WASTE WATER TREATMENT PLANT
AL KASIK MILITARY TRAINING BASE
AL KASIK, IRAQ

SIGIR PA-06-074
JANUARY 29, 2007

SUBJECT: Report on Waste Water Treatment Plant, Al Kasik Military Training Base, Al Kasik, Iraq (Report Number SIGIR PA-06-074)

Diagram 1. Diagram from contractor's submittal A-106 for clarifier torque calculations. The diagram does not show a vertical skimmer arm attached to the sweep arm.

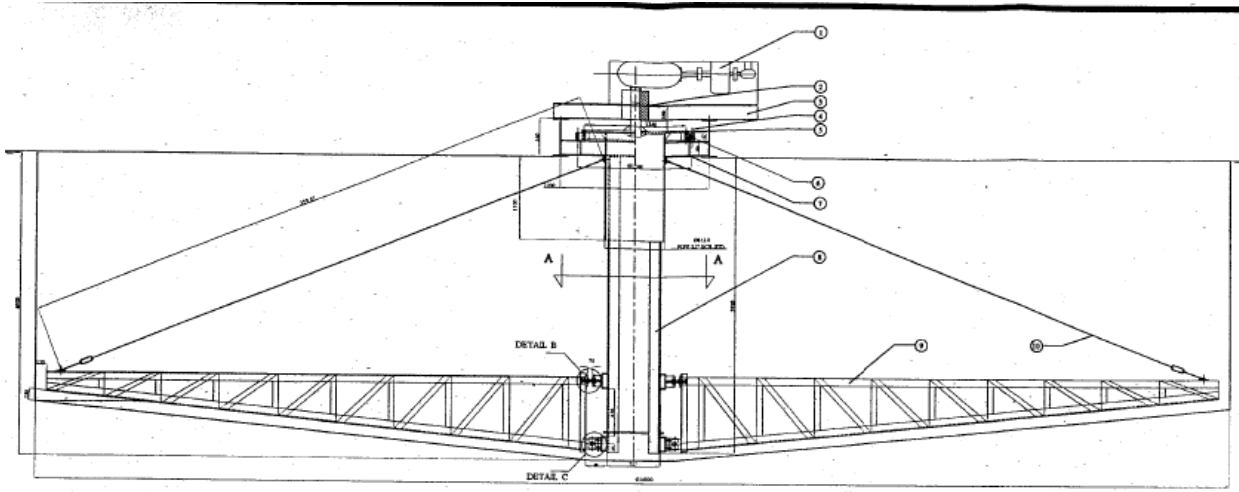
Sweeping occurs when the sweep arm assembly rotates around the bottom of the tank. The diagram below (Diagram 1) shows the approved design for the sweep arm assembly. The sweep arm assembly consists of two horizontal metal sweep arms that are supported by a rotating central shaft. Cables attached to the center shaft support the outer ends of the arms. Sweeping takes place by rubber flaps or scrapers attached to the bottom of each arm. The rubber scrapers are positioned to move the solids on the tank floor as the assembly rotates around the tank.

At the time of the assessment team's site visit, the D-7 Clarifier Tank was found to have been inoperable since 19 March 2006. Rather than resting in a level position, the horizontal sweep arm assembly (Diagram 1) was observed in an off-level position with one side lying on the floor of the tank while the opposite side was off the floor. In addition, the vertical main shaft of the clarifier tank's sweep arm assembly was off center and tilted. Lastly, the drive gearbox was broken beyond repair.

In that the skimmer structure was not part of the original design, engineering load calculations were likely understated. Changes in the design, such as the addition of the skimmer structure, altered the boundary conditions for the original torque analysis of submittal A-106. The absence of a properly calculated design change to account for the addition of the skimmer structure during construction was likely the catalyst for the series of failures that rendered the clarifier tank inoperable.

Diagram 2.

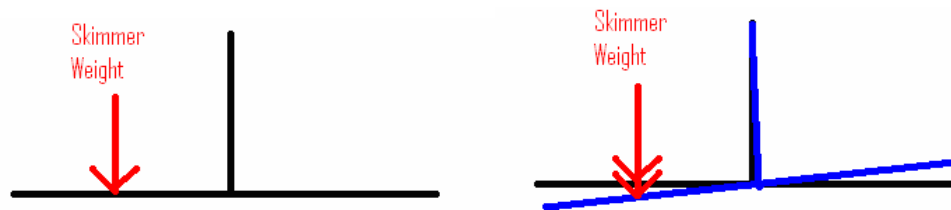
The off center vertical shaft was an indicator of an asymmetrical shaft load. The main shaft moved from center because of an unbalanced load caused by the added weight of the vertical skimmer structure attached during construction to one side of the horizontal scraper arm assembly. Conversely, the opposite side of the horizontal scraper arm assembly did not include a counterweight to offset the weight of the skimmer structure and unbalanced state of the horizontal sweep arm. In addition, an undetermined amount of additional drag force was created as the skimmer structure moved through the tank's liquid while the horizontal sweep arm assembly rotated. Accordingly, the overall load placed on the horizontal sweep arm assembly and drive gearbox likely increased substantially by the addition of the vertical skimmer structure. Simply put, the vertical skimmer structure attached during construction was big and heavy and caused the structure to be unbalanced. Diagram 2 illustrates the movement of the vertical shaft because of the unbalanced load on the horizontal sweep arm assembly. QA Photo 10 presented later in this report shows the skimmer assembly from the top while Site Photo 7 shows the skimmer from inside the tank.

An unbalanced load on the horizontal arm assembly caused stress on the vertical shaft which forced the shaft to an off center position.

Diagram 3. Pump Station G-03 from contractor's piping plan drawing.

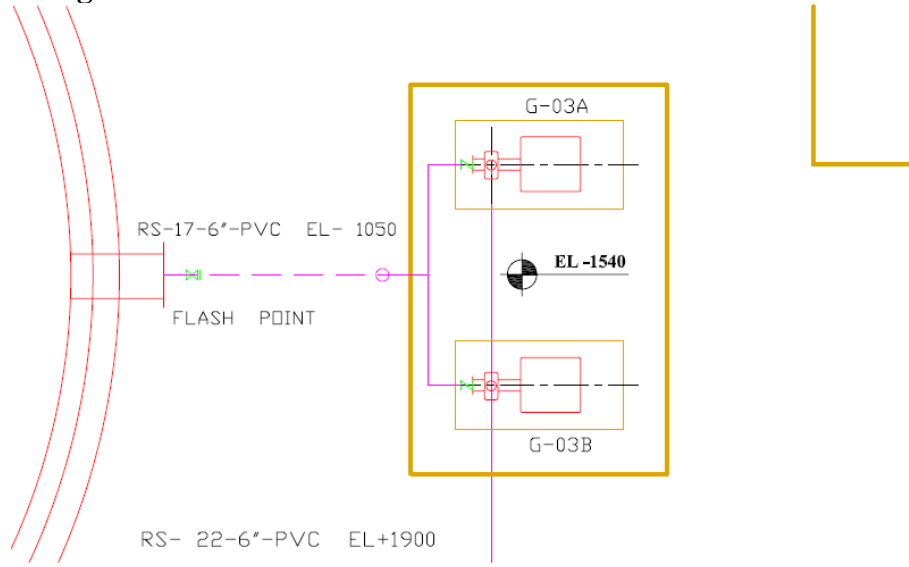
The G-03 pump station located beside the D-07 tank consisted of a below grade reinforced concrete pad with foundation walls. Placing the pumps below grade improved the efficiency of the pumps located on pads identified as G-03A and G-03B in Diagram 3. In addition, the diagram shows the relative location of the pump station in relation to the edge of the D-7 tank. In comparison to many of the concrete structures observed throughout the WWTP, the G-03 pump station was not a large structure. It measured approximately, 4.4 m (14.5 ft) by 2.7 m (9 ft) by 1.7 m (5.6 ft) deep. During the site visit, the assessment team observed significant fractures in the concrete structure along the base, walls, and corners of the G-03 pump station. A series of photos (Site Photos 11-18) illustrate what the assessment team observed while on site. Site Photos 11-16 were taken from inside the pump station while Site Photos 17 and 18 were taken from the outside.

Site Photos 11 and 12 show that sizeable vertical cracks crept up the rear wall of the pump station.

Site Photos 13 and 14 show the horizontal fracturing that occurred near the base of the structure and at a point approximately half way up the wall. The horizontal cracks were generally parallel to each other. Site Photos 15 and 16 show very similar horizontal cracks that wrapped around the opposite corners in the rear wall of the pump station.

During fieldwork discussions, the AFCEE/COR agreed that the pump station should be reconstructed to prevent continued degradation of the pump station and as a hedge against future failure in the G-03 pump station.

Diagram 4. Cross section of G-03 building from the contractor's A-41 submittal.

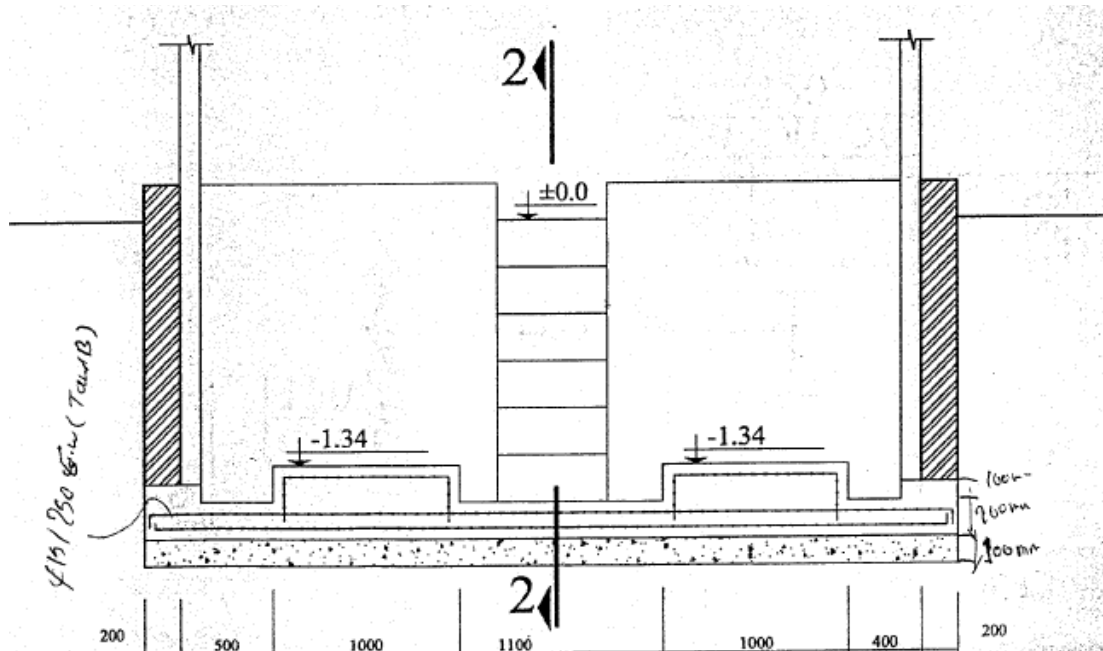
During a review of design and Quality Control documentation, the assessment team found contractor's submittal A-41, G-03 pump pad details, (Diagram 4) with comments that specified the BRC #63 should be replaced with steel bar reinforcement.

Based on the assessment team's observations, a review of design and QC documentation, and discussions conducted with the CMATT/RSU Engineer and the AFCEE/COR, the number of cracks of such magnitude indicated that abnormal stress was distributed across the rear concrete wall of the structure. In addition, such cracks were likely caused by, either/or a combination of, insufficient steel reinforcement of the concrete or inadequate soil compaction. The horizontal cracks that ran from corner to corner of the rear wall indicated that settling of the base slab was very likely. Inadequate soil compaction could cause such settling. Even if properly reinforced, much less if not sufficiently reinforced, the concrete wall would have been prone to cracking if constructed on soil that was not sufficiently compacted.
